Access Compliance Report

Public Rights-of-Way

Intersection ID: 30209	Main Street: HIDDEN_CREEK_DR	Cross Street: MONTBROOK_DR	Location: E
ADA ID: 65AAA75C32F0	Ramp Type: Perpendicular Diagonal	Initial Pass/Fail: Fail	Overall Compliance: No
Severity Score: 18.75			
Codes/Mitigation Info/Possible Solution		Field Measurements/Component Compliance

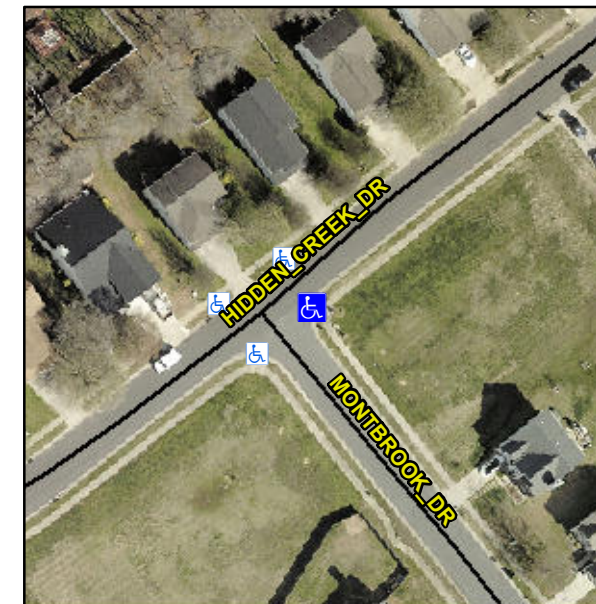
Not Found, R304.5.1, R304.5.3

Compliance	Description	Data	Compliance	Description	Data
N/A	Ramp Length (in)	44.5	Yes	Ramp Slope (%)	6.0
No	Ramp Width (in)	35.5	No	Ramp XSlope (%)	2.1
N/A	Flare Type LT	N/A	N/A	Flare Type RT	N/A
N/A	Flare Slope LT (%)	N/A	N/A	Flare Slope RT (%)	N/A
N/A	Flare Traversable LT?	N/A	N/A	Flare Traversable RT?	N/A
N/A	Landing Length (in)	N/A	N/A	DWS Provided?	N/A
N/A	Landing Width (in)	N/A	N/A	DWS Contrast?	N/A
N/A	Landing Slope (%)	N/A	N/A	DWS Length (in)	N/A
N/A	Landing X Slope (%)	N/A	N/A	DWS Full Width?	N/A
N/A	Landing Curb? (Y/N)	N/A	N/A	DWS Offset (in)	N/A
N/A	Shared Landing?	N/A			
N/A	Gutter Ponding?	N/A	N/A	Gutter Slope (%)	N/A
N/A	Gutter Lip Ht (in)	N/A	N/A	Gutter X Slope (%)	N/A
N/A	Painted X Walk1?	No	N/A	Painted X Walk2?	No
	X Walk 1 Direction	To NW		X Walk 2 Direction	To SW
N/A	X Walk 1 Width (in)	N/A	N/A	X Walk 2 Width (in)	N/A
	X Walk 1 Slope (%)	1.9		X Walk 2 Slope (%)	2.3
	X Walk 1 X Slope (%)	3.2		X Walk 2 X Slope (%)	1.0

Remove & Replace Curb Ramp With Two New Directional Ramps or Equivalent.
